ADDENDUM NO. 2

TO: PLANS AND SPECIFICATIONS FOR STATE OF MISSOURI

Third Floor Renovations MoDOT Millbottom Building Jefferson City, Missouri PROJECT NO.: 02225-01

3RD FLOOR PLANS

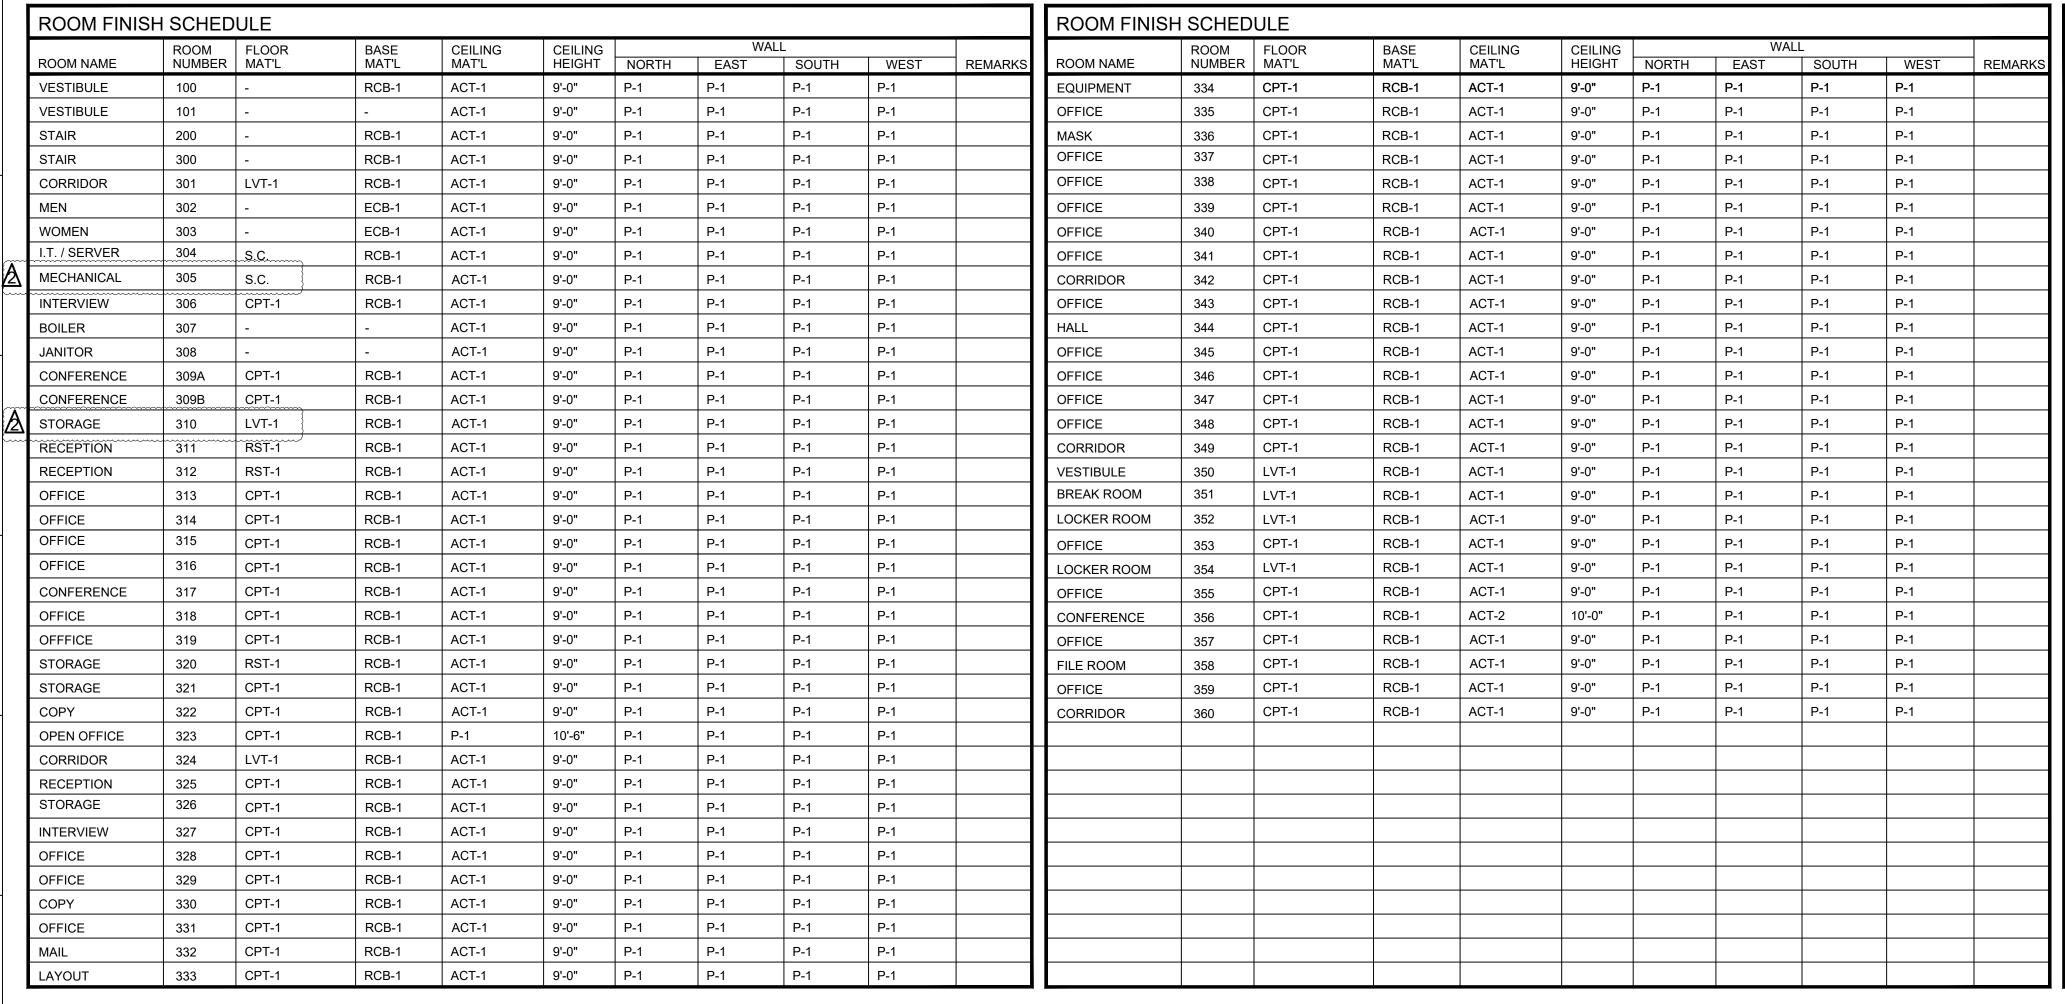
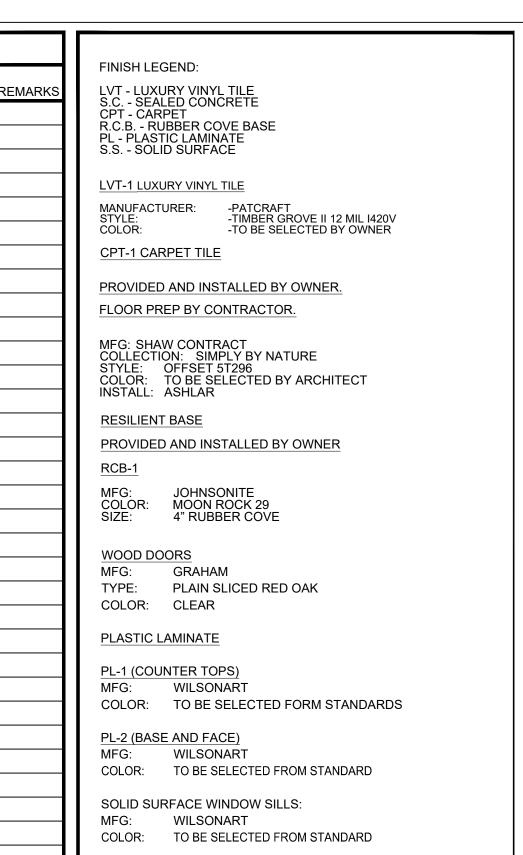
- 1. Sheet A-103
 - a. REVISE Room Names for Rooms 305 and 306.
- 2. Sheet A-106
 - a. REVISE Room Finish Schedule for Floor Material in Rooms 305 and 310.
 - b. REVISE Room Names for Rooms 305 and 306.
- 3. Sheet A-201
 - a. ADD Windowsill Details K10 and K13 to the sheet.
- 4. Sheet A-601
 - a. REVISE Room Finish Schedule for multiple rooms.

THIRD FLOOR ELECTRICAL DEMOLITION PLAN

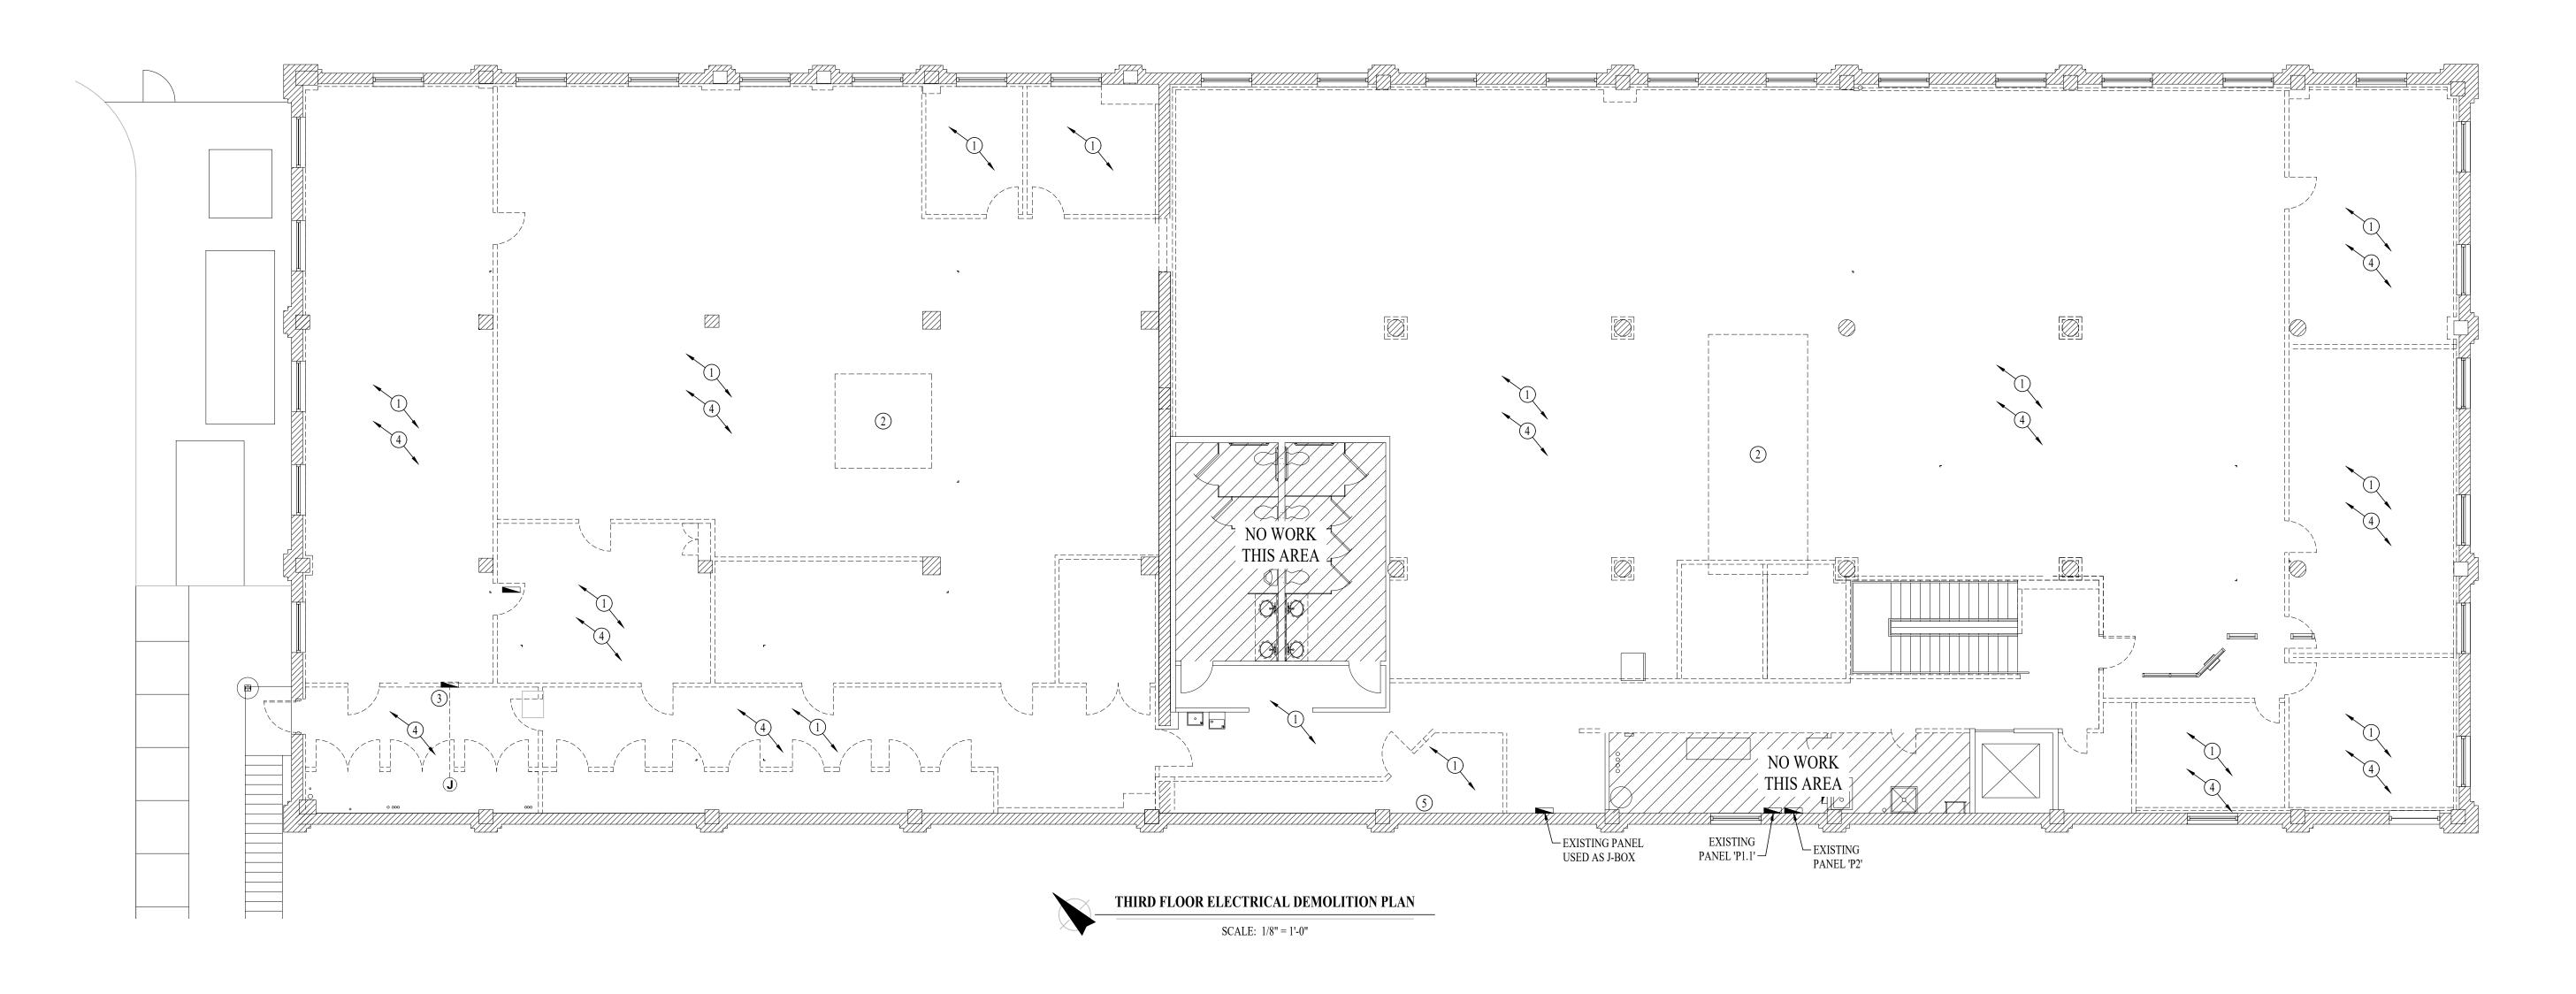
5. Sheet ED101

a. REMOVE AND REPLACE Electrical Demolition Plan Key Note No.2: Contractor to remove existing conduit & conductors feeding RTU. Conductors shall be removed back to existing breaker. Conduit shall be removed back to panel used as J-box.

THIRD FLOOR POWER PLAN

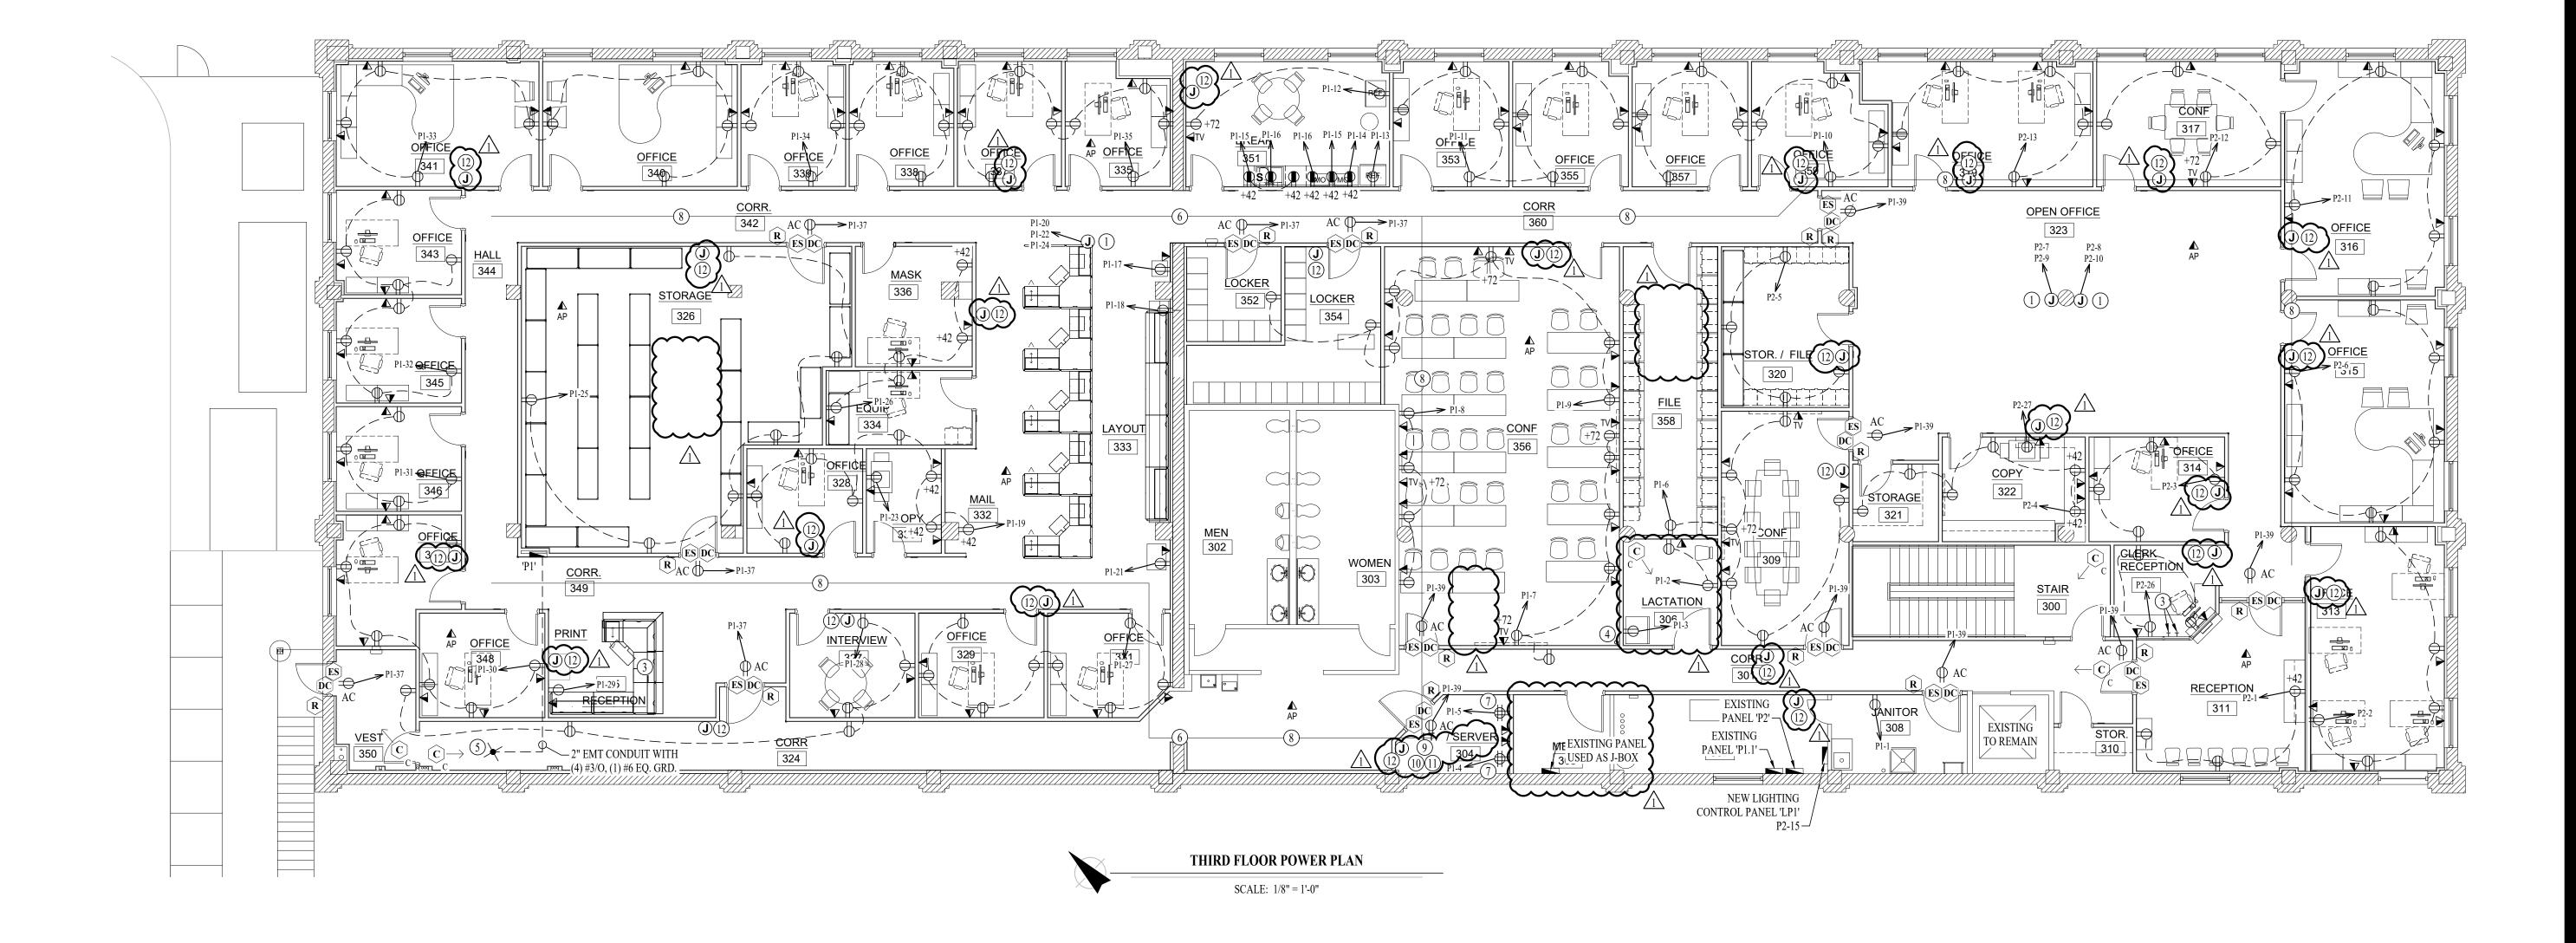
6. Sheet E101

- a. ADD Power Plan General Note 4: Security Devices are shown for rough-in only.
- b. REVISE Power Plan Key Note 8 to include coordinating location with HVAC Contractor on OA project # O2330-01 to prevent conflicts with new ductwork.
- c. ADD Power Plan Key Note 12: Provide 4x8 Box with mud ring & conduit up to above ceiling for future thermostat. Coordinate location with HVAC Contractor on OA project # O2330-01.
- d. ADD <u>Third Floor Power Plan</u> thermostat rough-in locations.
- e. REVISE power requirements in Room 305 and 306
- f. REMOVE HP-1 Note from Conference Room 356
- g. REMOVE FCU-1 Note from Server Room 304
- h. REMOVE RTU-2 Note from Storage Room 326

E102

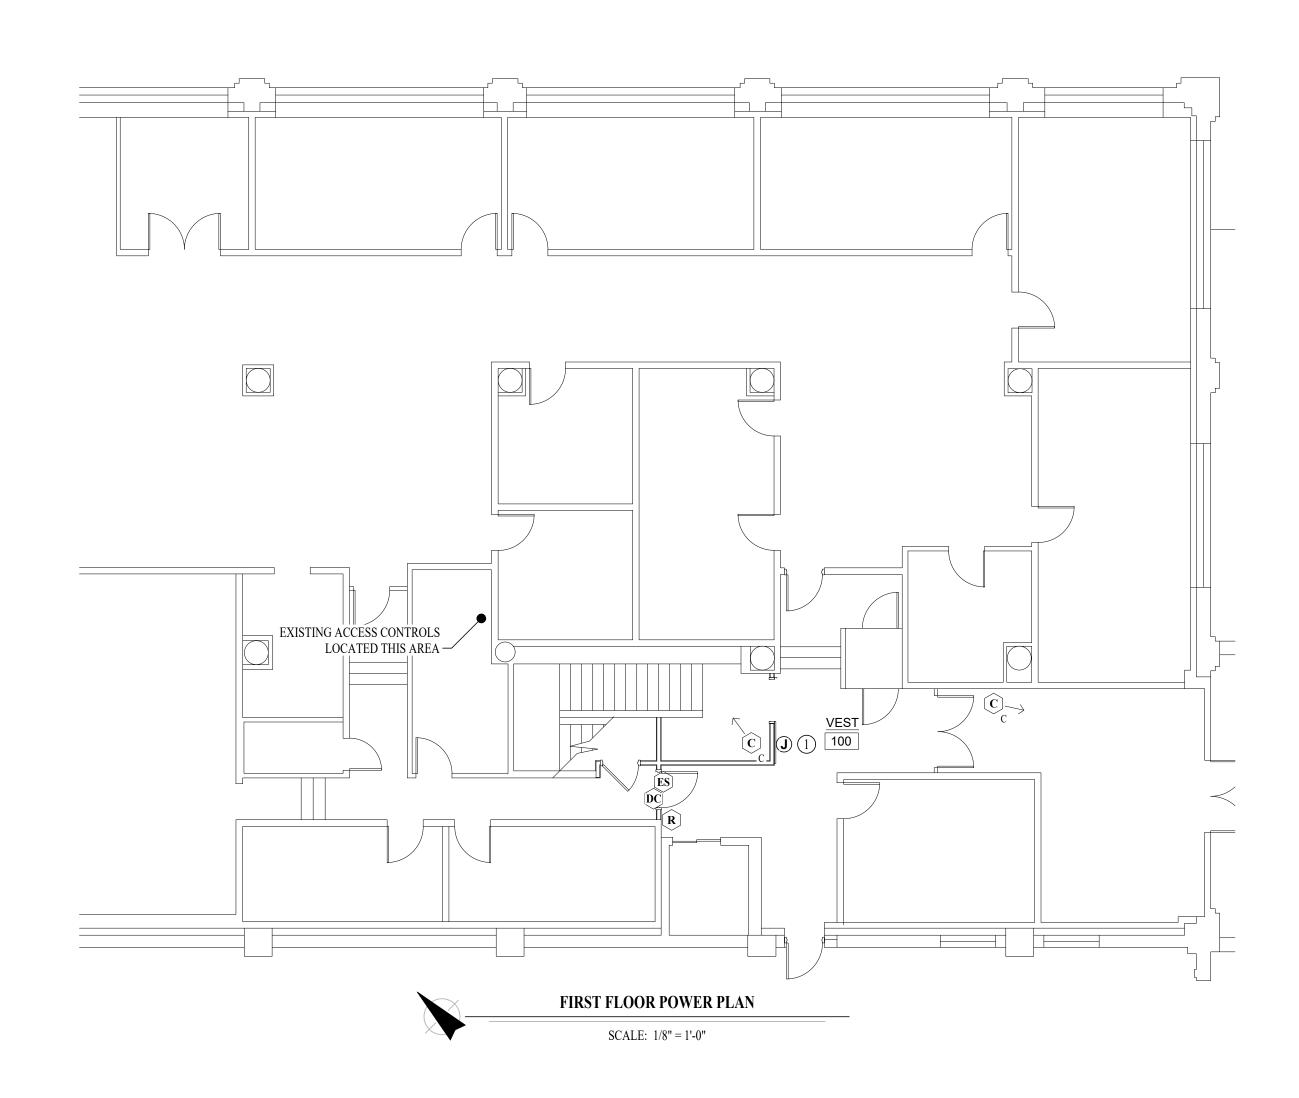
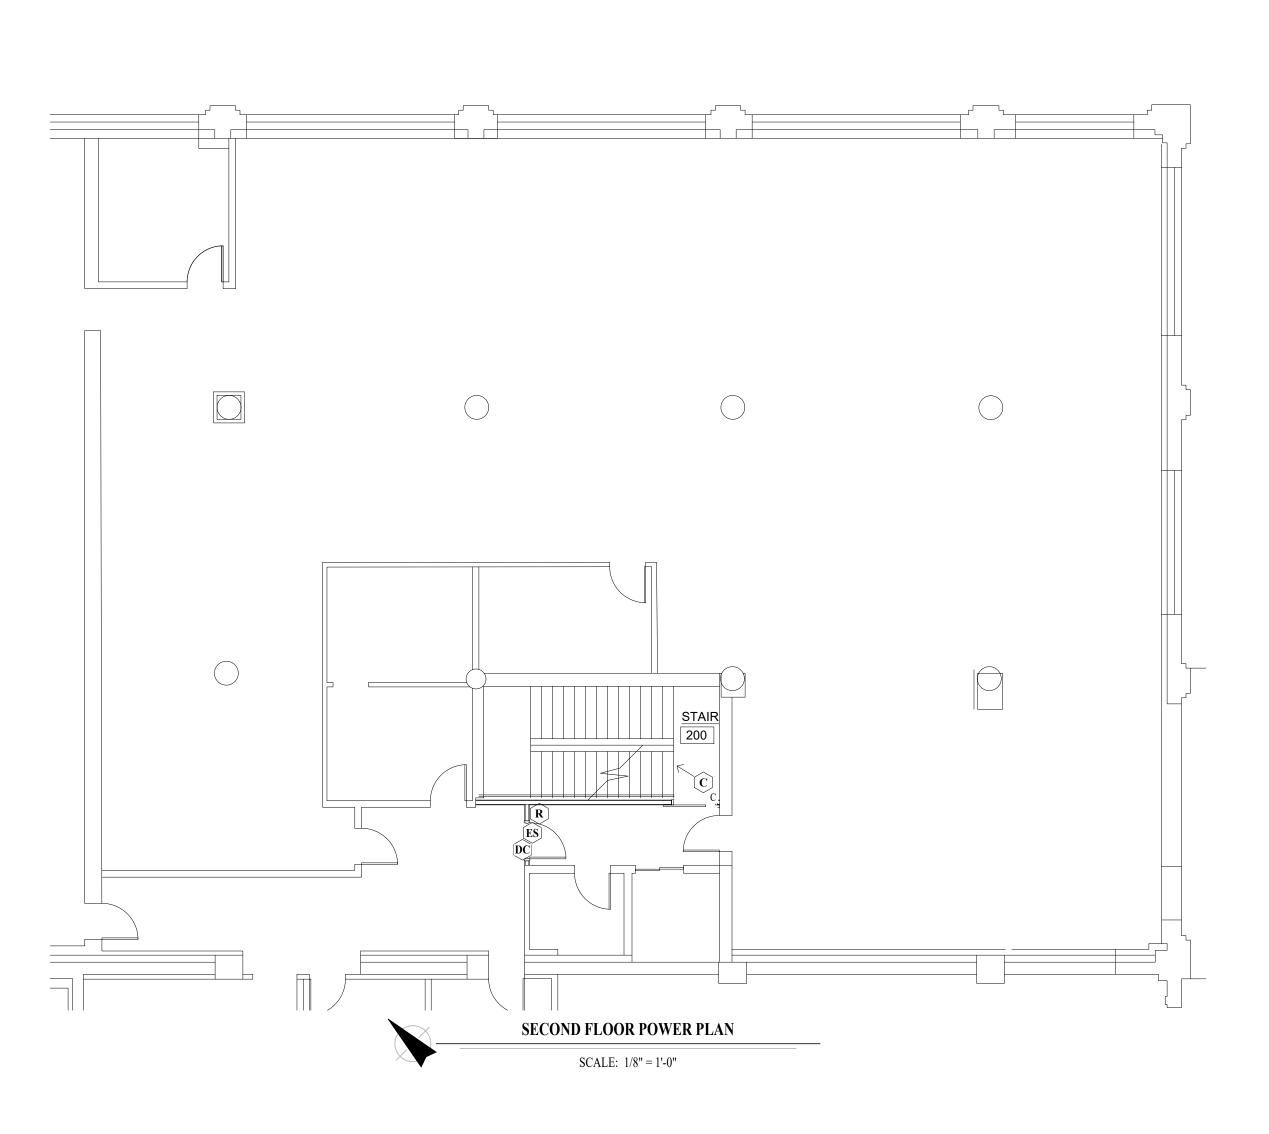
7. Sheet E102

a. ADD Power Plan General Note 2: Security Devices are shown for rough-in only.
